Item 3 Public Comments

Re: COASTAL DEVELOPMENT PERMIT CDP22-0021 TO DEMOLISH A SINGLE-

Re: COASTAL DEVELOPMENT PERMIT CDP22-0021 TO DEMOLISH A SINGLE-FAMILY DWELLING AND CONSTRUCT A SINGLE-FAMILY DWELLING WITH AN ATTACHED GARAGE AND MINOR SITE DEVELOPMENT PERMIT SDP22-0028(M) TO ALLOW RETAINING WALLS UP TO A MAXIMUM OF SEVEN (7) FEET IN HEIGHT, LOCATED AT 199 MONARCH BAY DRIVE.

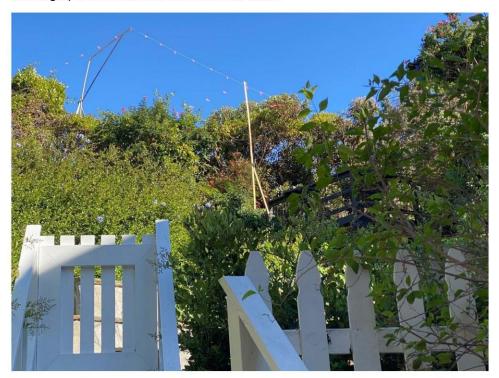
In response to our concerns and those of our neighbors at 63 and 67 South La Senda Drive (our three houses and the existing home at 199 Monarch Bay Drive are shown in the picture above) based on the original staking that was done (see photo below), the applicant modestly scaled back the initial plans of the project. We are appreciative of that effort and are grateful that there is a desire to be neighborly.

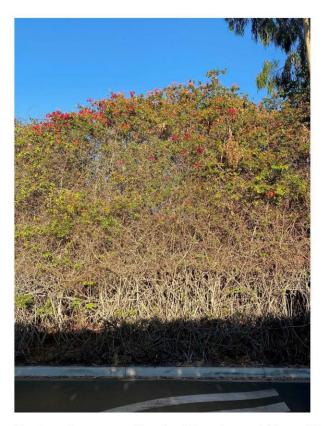
We are not arguing that nothing should be built, but homes along the top of the slope have long had a setback with pools on the side of the house and not built into the slope. This is the case with 203 Monarch Bay Drive and 205 Monarch Bay Drive, while 201 Monarch Bay Drive as depicted below has a large patio area also set back from the slope and on the side of the house. The picture also shows the close proximity of the slope to our property.
